TSG-RAN Working Group 3 meeting #4
Warwick, UK, June 1 – 4, 1999.

TSGR3#4(99)470

Title: Corrections to Synchronisation section in 25.401

2.3. *Regarding Section 9.3, Figure 8*

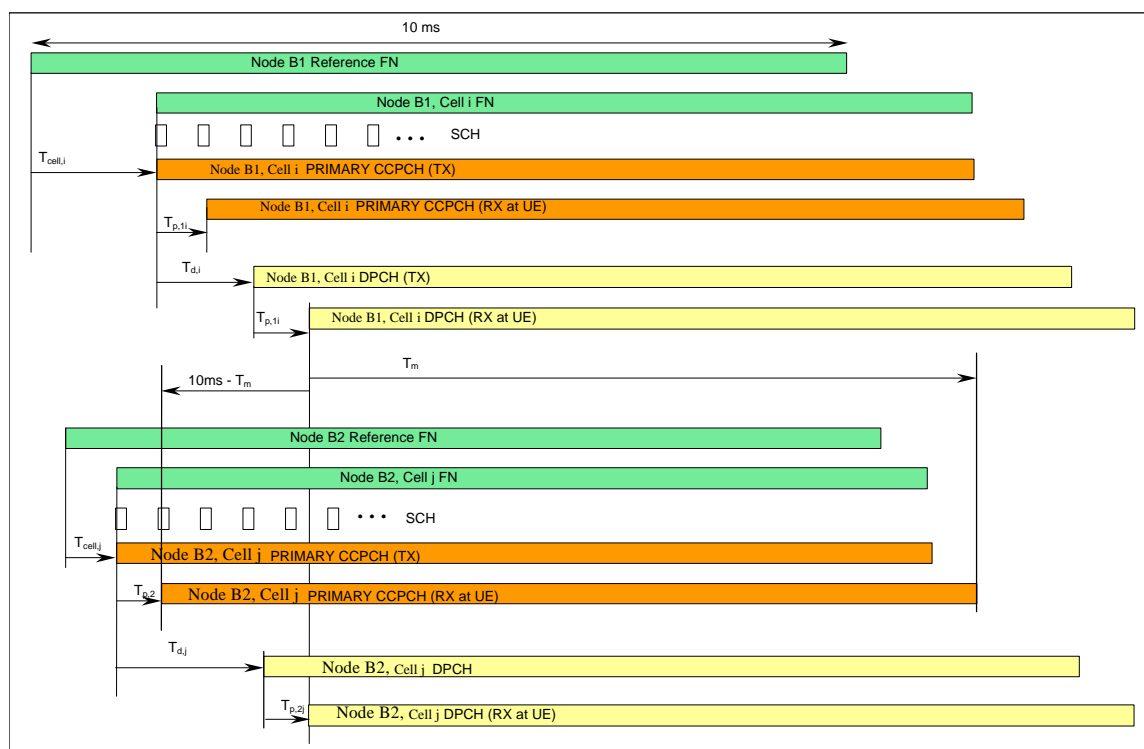
The way the figure is drawn implies that T_{dj} is a negative offset from the primary CCPCH of cell j . Every other figure in the document shows T_d as a positive offset from the boundary of the primary CCPCH. T_d should be shown always as a positive offset.

T_{dj} is implied to be a negative value not only due to the direction of the arrow but also since the figure implies that the absolute values of T_m and T_{dj} are equal. T_m is shown as the time that the primary CCPCH of cell j arrives after the DPCH of cell i , which is consistent with the assumption regarding T_m stated above.

The figure has been redrawn as shown below with T_{dj} as a positive offset with respect the primary CCPCH of cell j . To keep within the picture boundary, the primary CCPCH of cell j now arrives before the DPCH of cell i . Note that the length of the arrow ($10\text{ms} - T_m$) is equivalent to the length of the arrow for T_{dj} .

1. Delete the reference to [7] or add the correct document to the reference list in section 9.3.
2. Indent the two bullets following the definition of Td in section 9.3.
3. Replace figure 8 with figure in section 2.3 of this contribution.
4. Correct input parameters for calculation of Tdj in section 9.3 and figure 9.
5. Correct subscript of TX cell in figure 12.
6. Verify with WG2 that L3 signalling allows the UTRAN to inform the UE that it is not required to report OFF parameter.
7. In section 9.4.5, clearly state that SRNC is responsible for detection of uplink frame arrival too early/late and that Node B is responsible for detection of downlink frame arrival too early/late.
8. Correct definition of DL-Frame-Offset so that it is not reliant on knowledge of frame synchronisation.
